Urgent Field Safety Notice

StealthStation[™] Cranial and Synergy[™] Cranial

Depth Gauge Inaccuracy

Medtronic reference: FA848

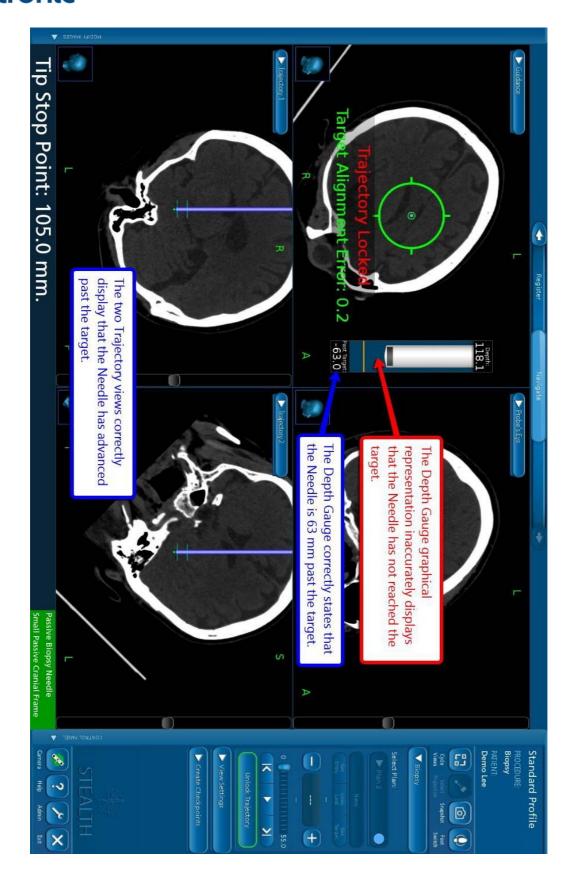
The image on page two contains an example of the error use case. All views correctly show that the instrument is past the target, and the Depth Gauge correctly displays the past-target measurement of -63, which indicates the instrument tip has advanced 63 mm beyond the intended target. However, the graphical Biopsy Needle cut window appears not to have advanced to the target position.

If the surgical team relies solely on the graphical representation in the Biopsy Depth Gauge feature and disregards other factors (such as setting the Mechanical Depth Stop on the Biopsy Needle to the indicated length, using the correct display within the Trajectory views, and using the 'distance to target' values within the anatomical views), the Biopsy Needle could be inserted too deeply, resulting in potential biopsy of healthy brain tissue or damage to critical structures.

- Do not set a projection longer than the length of the surgical plan.
- Per the Cranial Software Pocket Guide, always use the Biopsy Needle Mechanical Depth Stop.
- Ensure Navigate Instrument Tip setting is selected prior to locking the trajectory and subsequently navigating the instrument (see image below).
